ORIGINATION FORM

Proposed Revisions to a Standard Plans Index
(Please provide all information — Incomplete forms will be returned)

Index Number: 700-020
Sheet Number (s): 1, 2, & 3
Index Title: MULTI-COLUMN GROUND SIGN

Index Number: 700-020
Sheet Number (s): 1 and 3
Index Title: Multi-Column Ground Sign

LAST REVISION	11/01/22	REVISION	23	DESCRIPTION:	 FY 2023-24 STANDARD PLANS	MULTI-COLUMN GROUND SIGN	INDEX 700-020	SHEET 1 of 3
---------------	----------	----------	----	--------------	--	--------------------------	------------------	-----------------

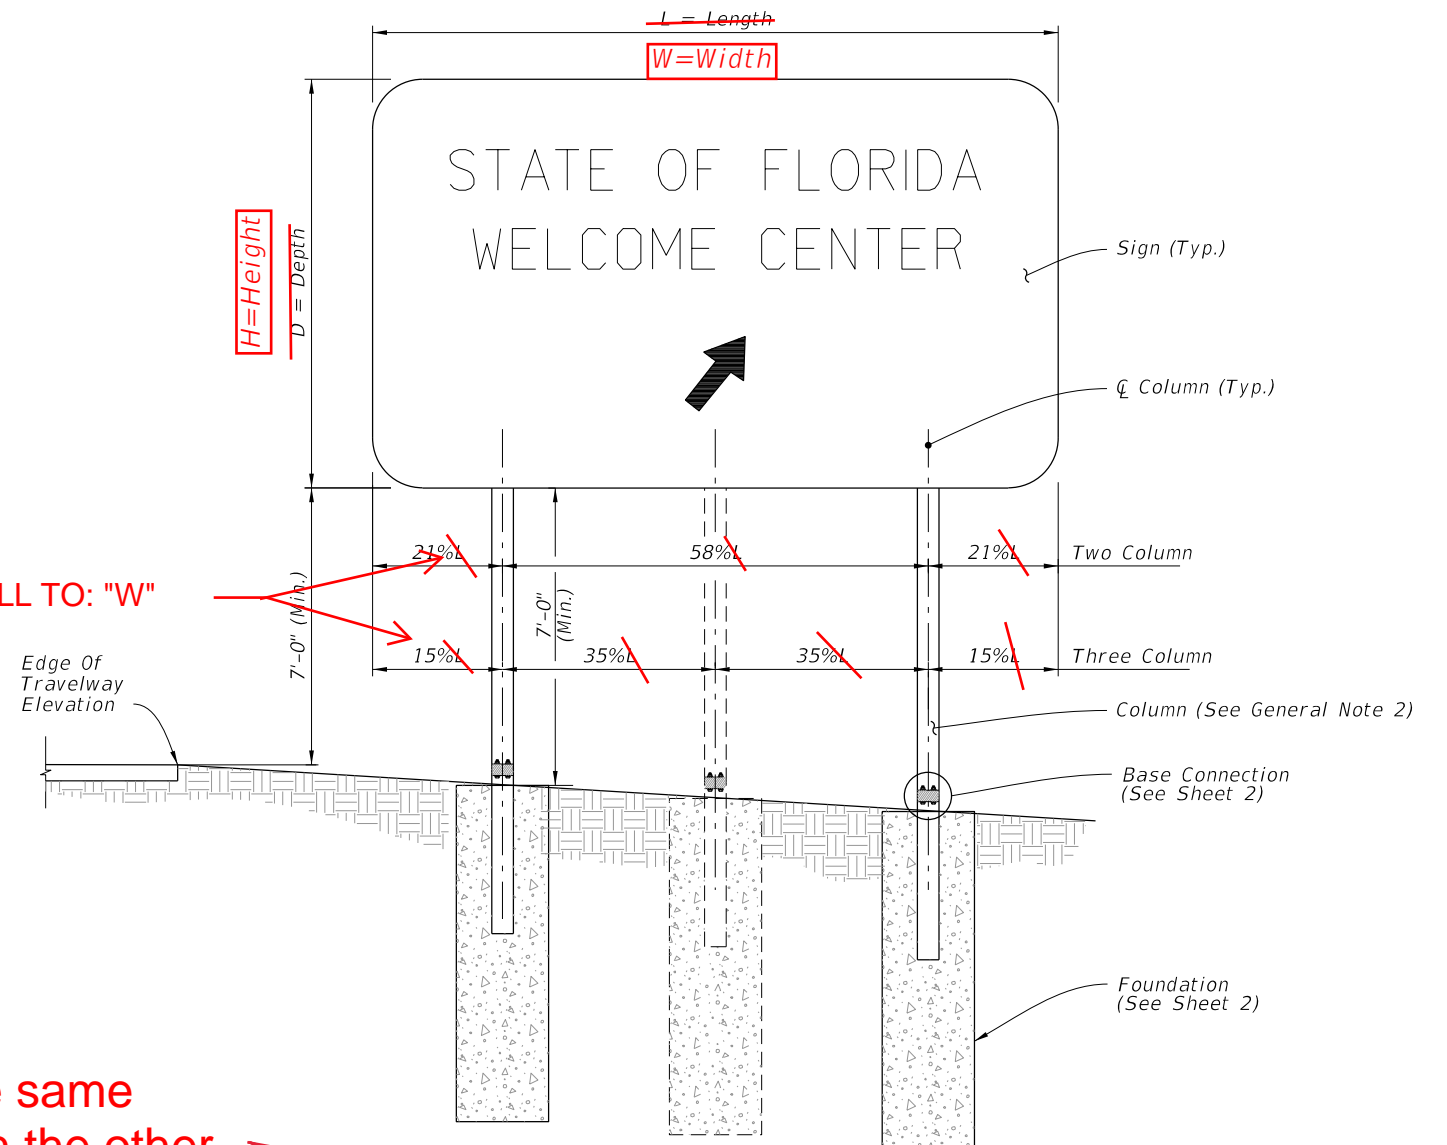
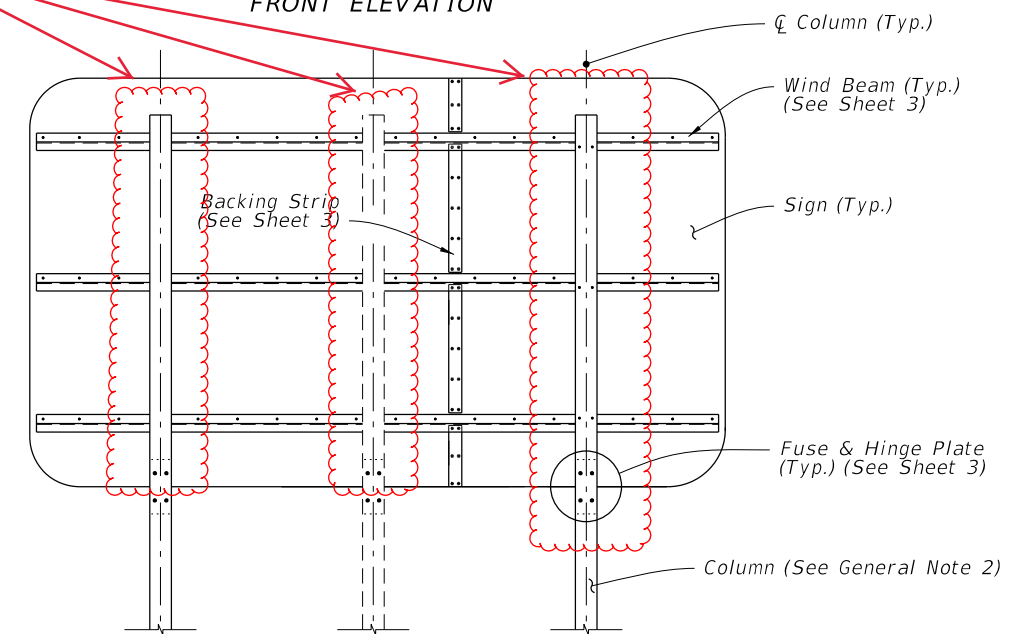
- Sheet 1: Revised bolts in the Hanger Beams to show correctly.
- Sheet 2: Added Foundation Notes to allow for precast concrete foundation with an octagon shape as a substitute for the circular shaped foundation shown.
- Sheet 3: Revised bolts in the Hanger Beams to show correctly.

- Sheets 1 & 3: The bolts were not showing correctly in the elevation details.
- Sheet 2: A non-circular, octagon shaft option was requested by industry to simplify formwork. (Revision by Richard Stepp)

- A. Sign Support Shop drawings are not required when fabricated in accordance with this Index and support columns do not exceed the ~~length~~ ^{width} shown in the plans by more than 2'-0".
- B. Sign Panels: Horizontal panel splices are allowed at interior wind beams for sign panels with a ~~depth~~ ^{height} ("D") greater than 10 feet. Shop drawings required for horizontal panel splice details.
- C. ~~When~~ ^{Shop} drawings are required, obtain approval prior to fabrication.

CHANGE TO: height ("H")

CHANGED TO: width ("W")

CHANGED ALL TO: "W"

Show the same bolting on the other wind hanger beams

== MULTI-COLUMN SIGN ASSEMBLY ==

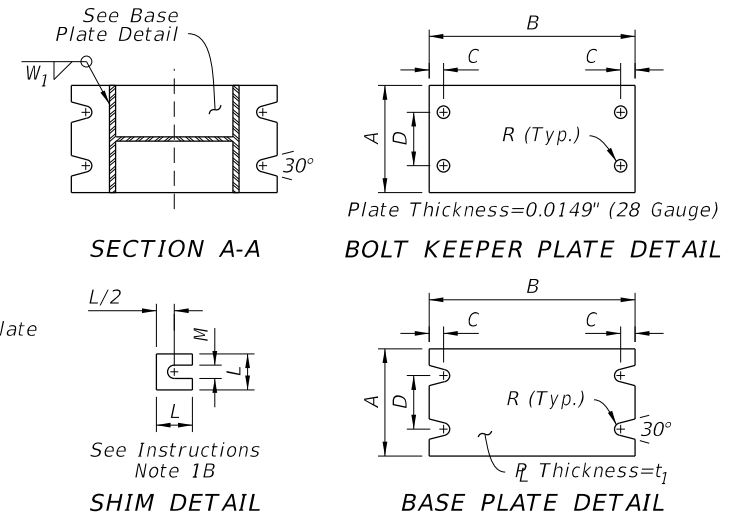
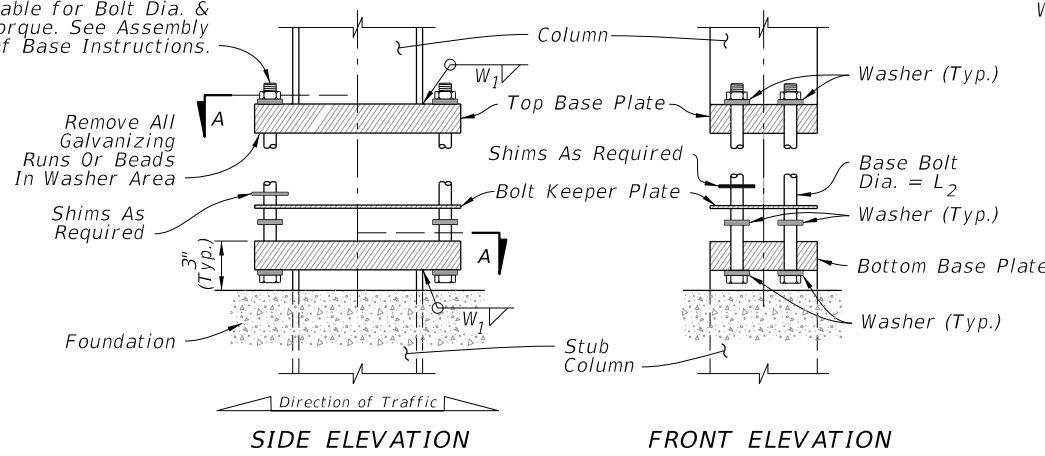
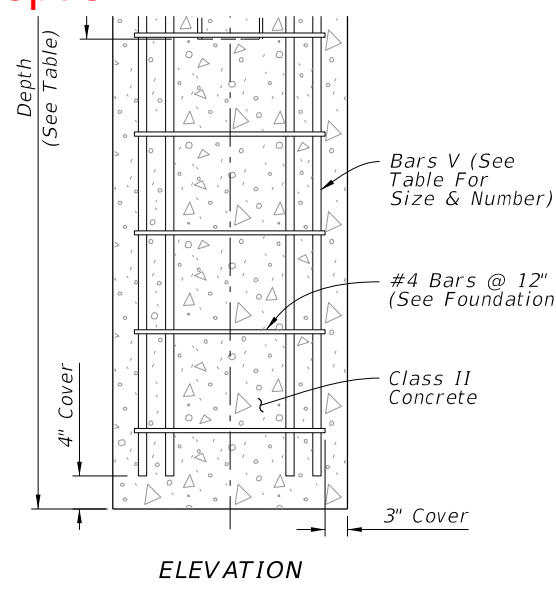
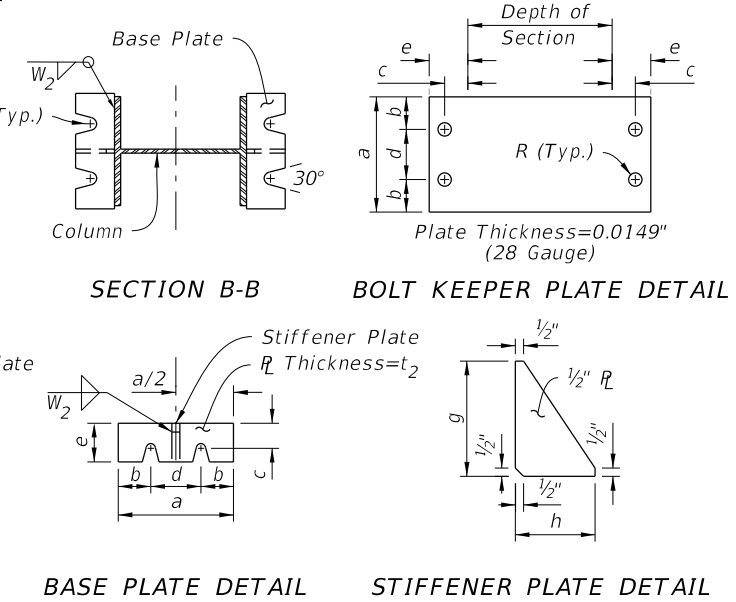
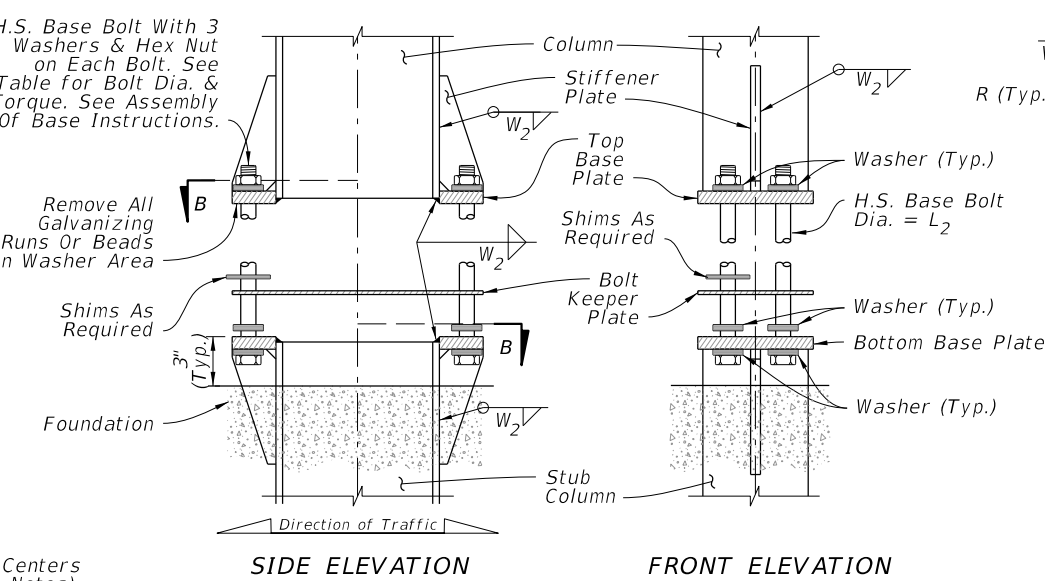
Revised note to add precast foundation option

Added note to explain the precast octagon shape option

The foundation may be either precast or cast-in-place. Use Reinforcing bars or equivalent Welded Wire Reinforcement.

For precast foundations, the circular cross section shown may be substituted with an octagon shape. The out-to-out distance between parallel edges must be greater than or equal to the diameter in the Foundation Data table. Use the same reinforcing diameter with centered placement and a minimum 3" cover.

WIND BEAM, BACKING STRIP & FUSE/HINGE PLATE DETAILS

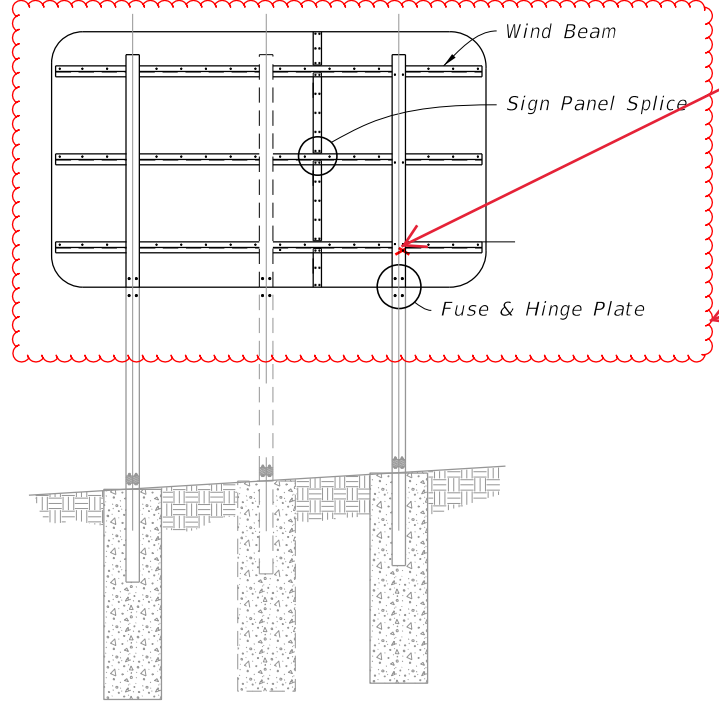
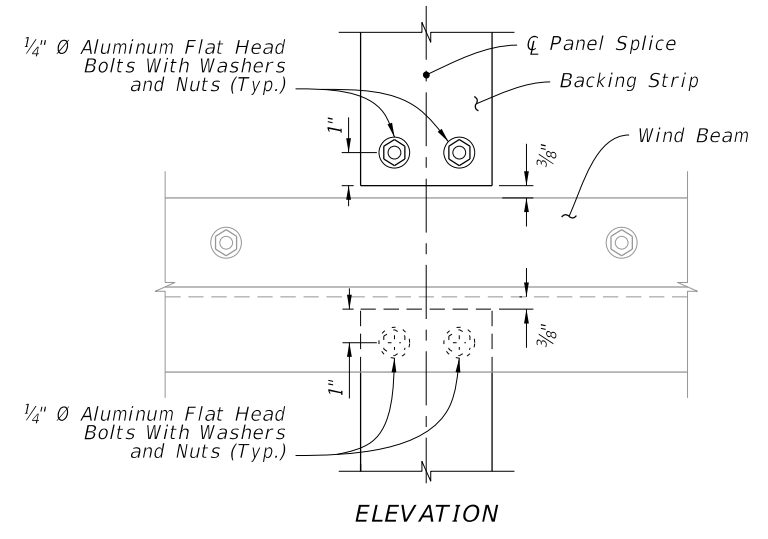
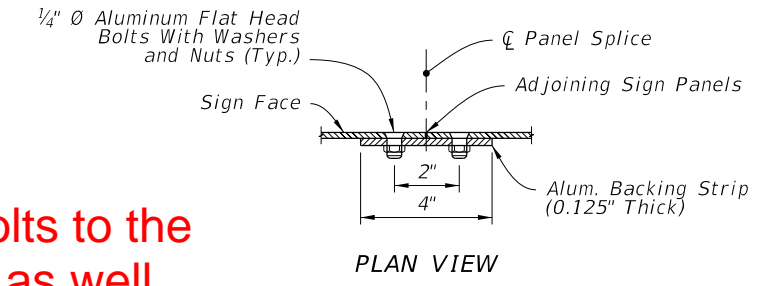
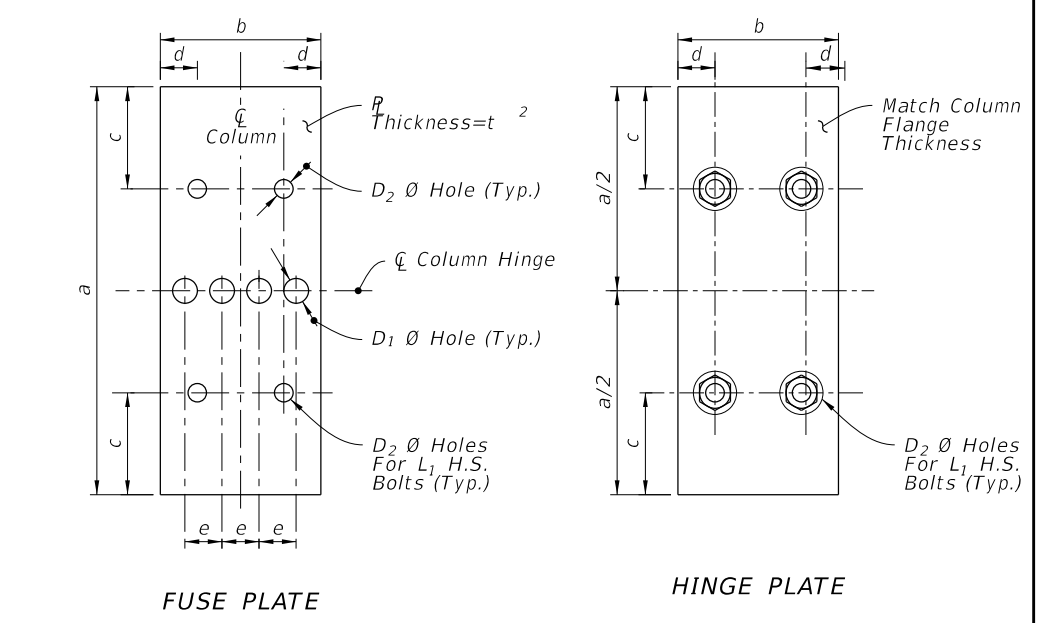
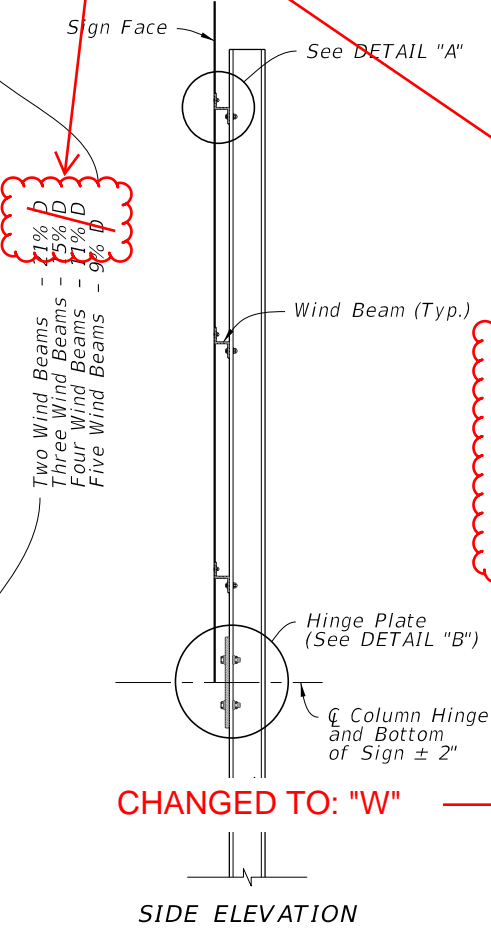
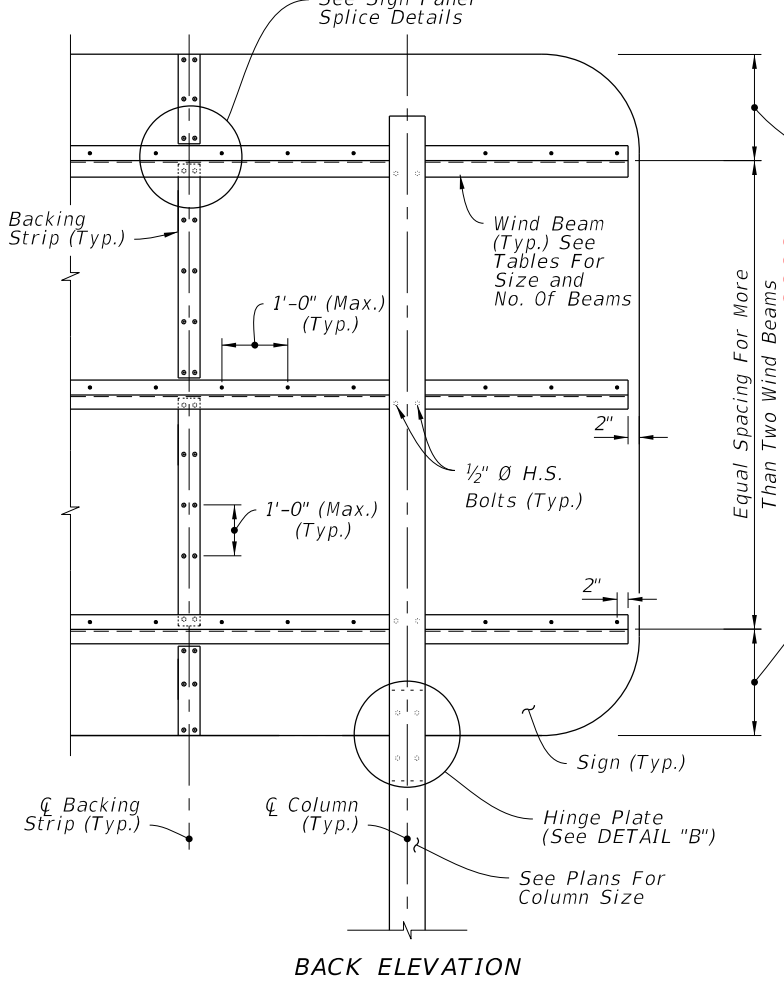
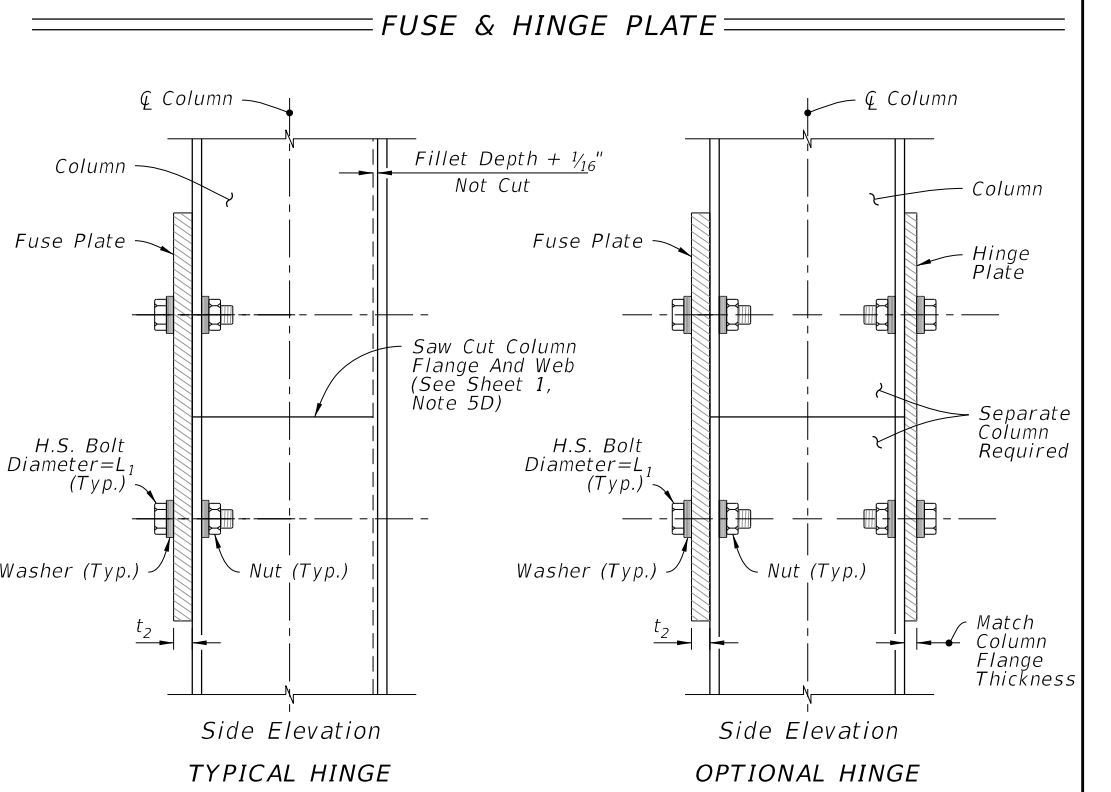
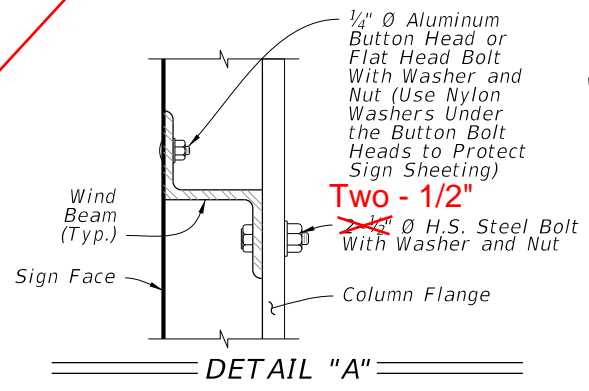
Only 2 bolts per intersection

Added the bolts to the other beams as well

BACK ELEVATION CHANGED TO: "H"

CHANGED TO: "W"
